From: writtentestimony
Sent: Monday, March 02, 2015 4:24 PM
To: writtentestimony
Subject: FW: Public Comment on Takoma Metro Station Public Hearing Staff Report, Docket R14-01

Re: Docket No. R14-01:

Proposed Changes to WMATA Facilities at Takoma Metro Station

OPTION 3b - LOWER LEVEL ELEVATOR ENTRANCE CONCEPT PLAN

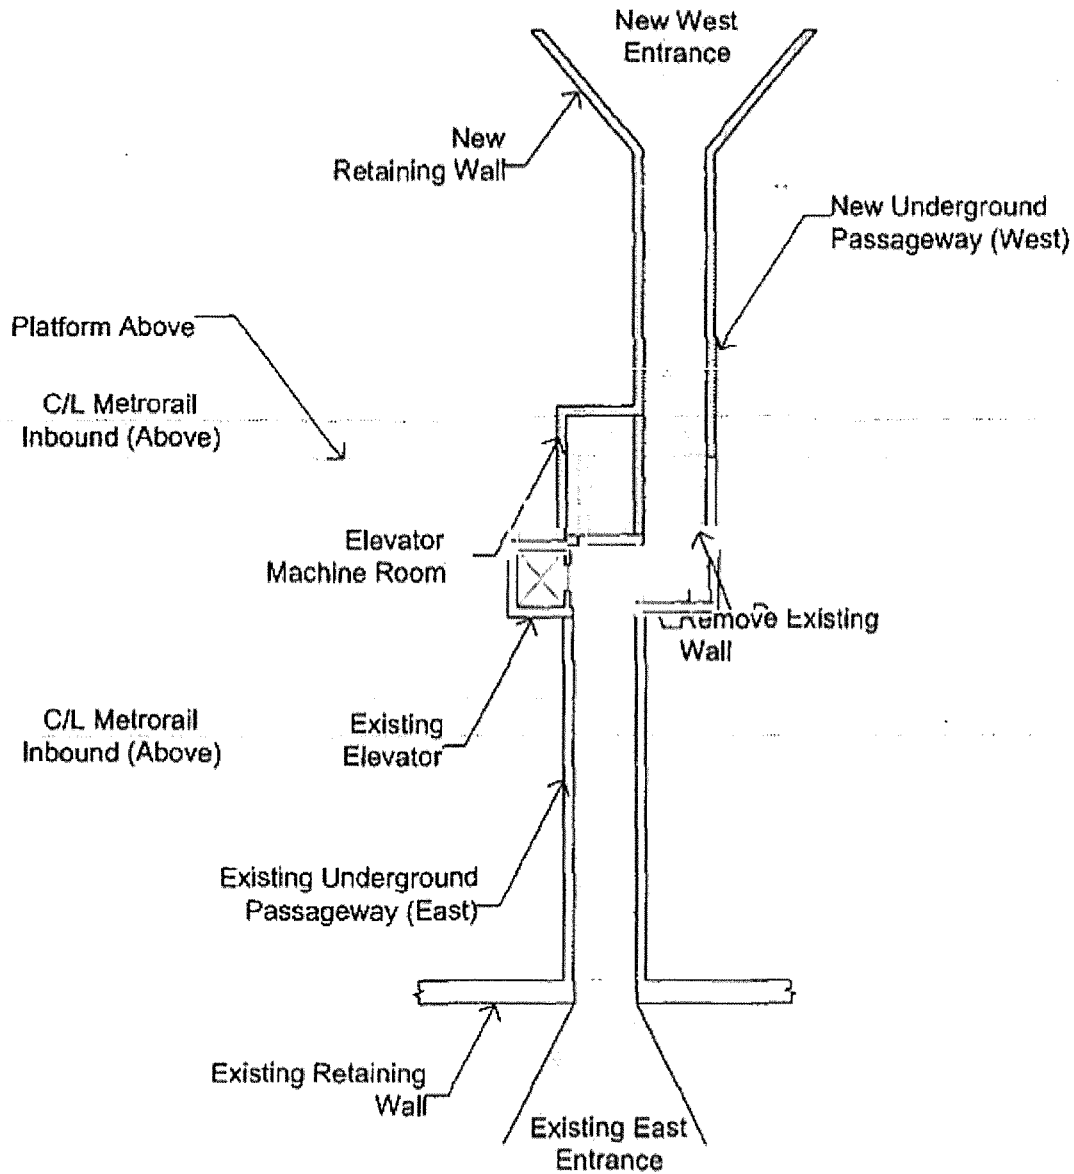
On page 16, the Takoma Public Hearing Staff Report used a 2006 study to estimate that completing the tunnel accessible/bicycle tunnel under the tracks would be too expensive. That study said that the tunnel was costly because of the location of the elevator machine room. My verbal testimony was mangled in transcription, but in my written testimony, I (writing on behalf of Seekers Church) I suggested a "Jog" around the machine room. I also included a mock-up, also attached, of how that might look.

I submit that the feasibility of a tunnel that leaves the machine room in place be examined before rejecting the proposal because of the cost of moving the machine room. This is an opportunity to finance opening up the bicycle entrance to the trail, as called for in DC's Central District Plan which was passed unanimously by the DC city council. Furthermore, a through tunnel would provide handicap access to new residential development on the western side of the tracks, such as the 150 units planned for Spring Place.
